VIRGINIA ELECTRIC AND POWER COMPANY
RICHMOND, VIRGINIA 23261

VIRGINIA ELECTRIC AND POWER COMPANY
SURRY POWER STATION UNITS 1 AND 2
SIX-MONTH STATUS REPORT IN RESPONSE TO MARCH 12, 2012 COMMISSION
ORDER MODIFYING LICENSES WITH REGARD TO RELIABLE SPENT FUEL POOL
INSTRUMENTATION (ORDER NUMBER EA-12-051)

Response to SFPLI RAIs and Safety Evaluation Review Item 1

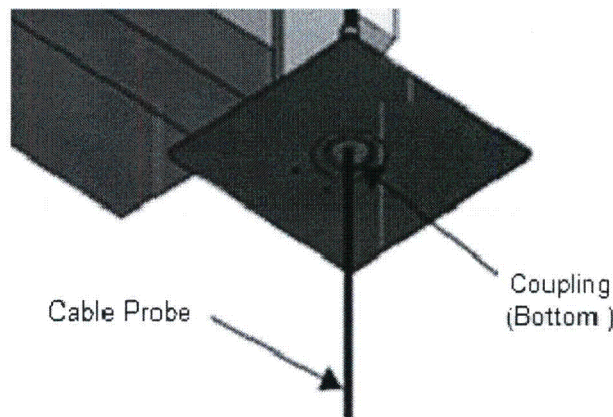
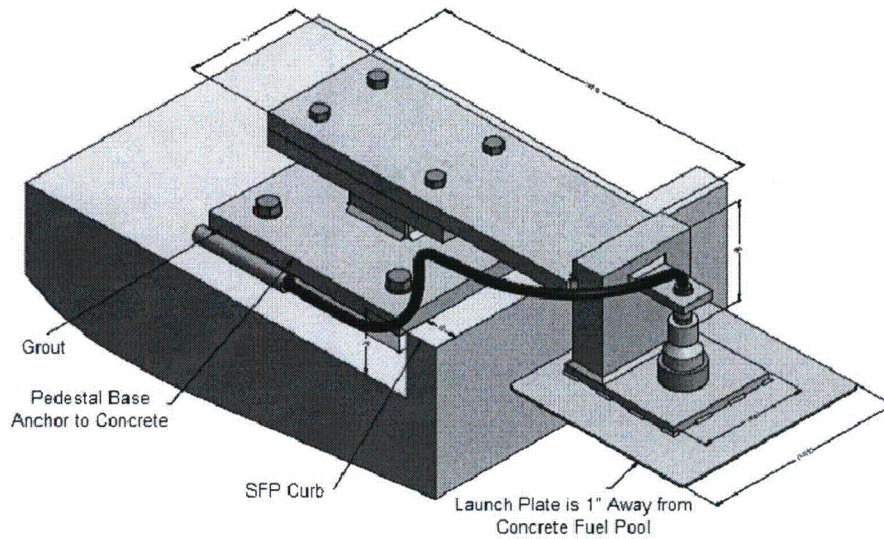
b) A description of the manner in which the level sensor will be attached to the refueling floor and/or other support structures for each planned point of attachment of the probe assembly. Indicate in a schematic the portions of the level sensor that will serve as points of attachment for mechanical/mounting or electrical connections.

c) A description of the manner by which the mechanical connections will attach the level instrument to permanent SFP structures so as to support the level sensor assembly.

b) The level sensor consists of the braided stainless steel cable level probe, which is attached to the mounting bracket and extends into the pool. The attachment to the bottom of the mounting bracket and to the signal cable is made via a coaxial coupling. The mounting bracket is attached to the SFP structure at the concrete curb utilizing expansion-type concrete anchor bolts. The probe is not attached to the floor of the pool.

The following simplified drawings show a representation of the attachment of the probe and the sensor cable to the mounting bracket (launch plate) and mounting bracket attachment to the SFP structure.

c) The level sensor (probe) is designed to be attached near its upper end to the mounting bracket, as described in the response to RAI #2b above. The mounting bracket is attached to the SFP concrete curb utilizing expansion-type concrete anchor bolts. The mounting bracket to the SFP structure concrete curb anchorage is designed to meet the requirements of the Surry design basis for Seismic Category I components including seismic loads, static weight loads and hydrodynamic loads.
